FIELD SERVICE BULLETIN

FSB Number: LVCCFSB2006-98 Rev(A)
Author: Eduardo Rodriguez
Date: March 10, 2006 (Updated March 30, 2006)
Total No. of Pages: 3
Subject: **3G V3x – 5571967B01- Hinge Cam – Difficulty opening and closing flip**
Phone Models: 3G V3x
Level of Repair: 2

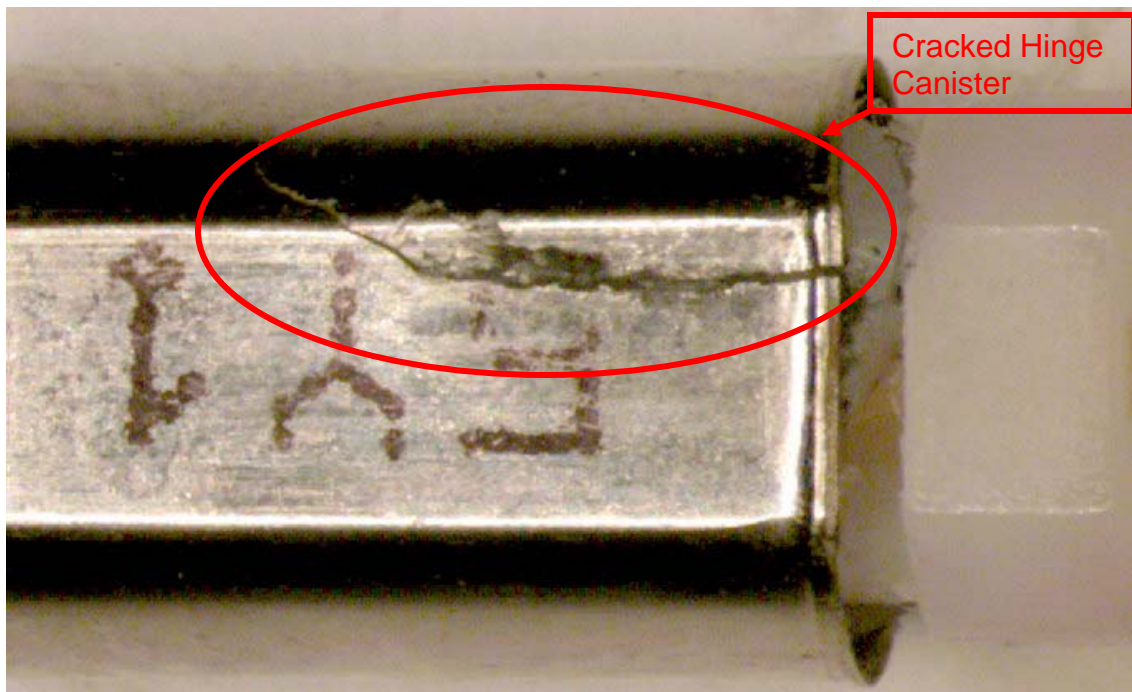
Service is aware of an issue; identified by the field on V3x. Units were returned with a customer complaint of “Difficult opening and closing the flip.” Analysis revealed the hinge canister (Part # 5571967B01) to be cracked due to its thin wall design. (See Fig. 1) The flip becomes difficult to open as the material inside the canister wears and then starts to rotate within the canister, see Fig 2.

- a. Part change to 5571967B03, date code 634 or later – Increased wall thickness and changed from brass to stainless steel material. See fig. 3 on how to read date code.
